## **REVISION TO MANUSCRIPT DRAFT**

#### Wind Energy Science Discussion

### What are the benefits of lidar-assisted control in the design of a wind turbine?

Figure 1. Comparison between the WS-Dependent (defined based on Bottasso et al. (2014)) and WS-Independent scenarios.

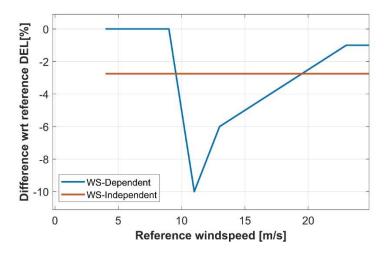
- 6. [Reviewer] *Line 115: "guaranteeing" (spelling)*[Authors] Thank you, we have corrected this typo.
- **7. [Reviewer]** Line 169: "it is assumed that load reductions are independent of wind speed" seems a strange statement. Load reductions may be much greater above rated when pitch control is active, and can depend strongly on wind speed.

**[Authors]** The assumption of load reductions being independent of wind speed is clearly an approximation, which only holds true when the reduction coefficients are small. The impact of this assumption was found to be negligible for small reduction coefficients.

This conclusion was obtained as follows. A dedicated study was conducted by first defining a wind-speed-dependent scenario, which was obtained from Bottasso et al. (2014)<sup>8</sup>. That study reports the wind-speed-dependency of the reduction in tower-base fore-aft DEL obtained with a Lidar-enhanced control strategy for a 3 MW machine. This wind-speed-dependent reduction scenario was applied to the WT3 machine, this way obtaining an equivalent Weibull-averaged DEL of -2.75%. A wind-independent scenario was then defined by assuming a constant profile, in which the reduction for each wind speed is equal to 2.75%, i.e. the same value as the Weibull-averaged DEL. The comparison between the two scenarios is shown in Fig. 1.

Finally, both scenarios were applied to the WT3 machine, and the fatigue margin at the tower base was computed, resulting in a change of only +1.02% for the WS-Independent scenario with respect to the (more accurate) WS-dependent one.

The study was extended by considering progressively larger reduction conditions for both the WS-Dependent and WS-Independent scenarios. Results shows that the difference between both scenarios increases for higher load reductions; however, the difference remains small. For example, considering the DEL flapwise blade root moment reduction of the model, which is equal to -3.8%, the difference in fatigue margin at the blade root between the WS-dependent and independent scenarios was found to be less than 2%; for the DEL fore-aft bending moment at tower base, which is equal to -12% according to the model, the fatigue margin difference was found to be approximatively equal to 5%. For all cases, the WS-Independent scenario leads to a higher fatigue margin, implying that the application of a WS-Independent scenario underestimates the effect of a real WS-Dependent scenario (and hence overestimates the benefits of LAC).

For the load-reductions of the present investigation, the error generated by assuming the WSindependent scenario was assumed to be negligible, at the light of the other approximations already present in the analysis.

Figure 2. Mass difference of the updated baseline towers (non-LAC) wrt initial 20-year baseline

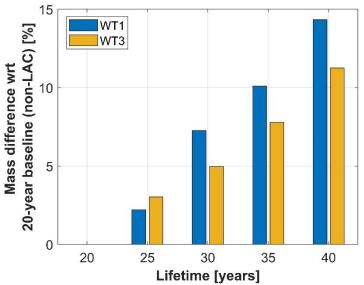
**9. [Reviewer]** *It would be nice to display the non-LAC mass increases compared to 20 yr life, and how they change with LAC.*

**[Authors]** Figure 2 (in this reply to the reviewers) displays the mass of the updated non-LAC baselines (redesigned for each lifetime) with respect to the initial non-LAC 20-year baseline. Figure 3 reports the mass of the LAC-enabled redesigned towers with respect to the corresponding non-LAC baseline tower.

These plots show how the LAC-enabled redesign counteracts very nicely the mass increase introduced by the longer lifetime.
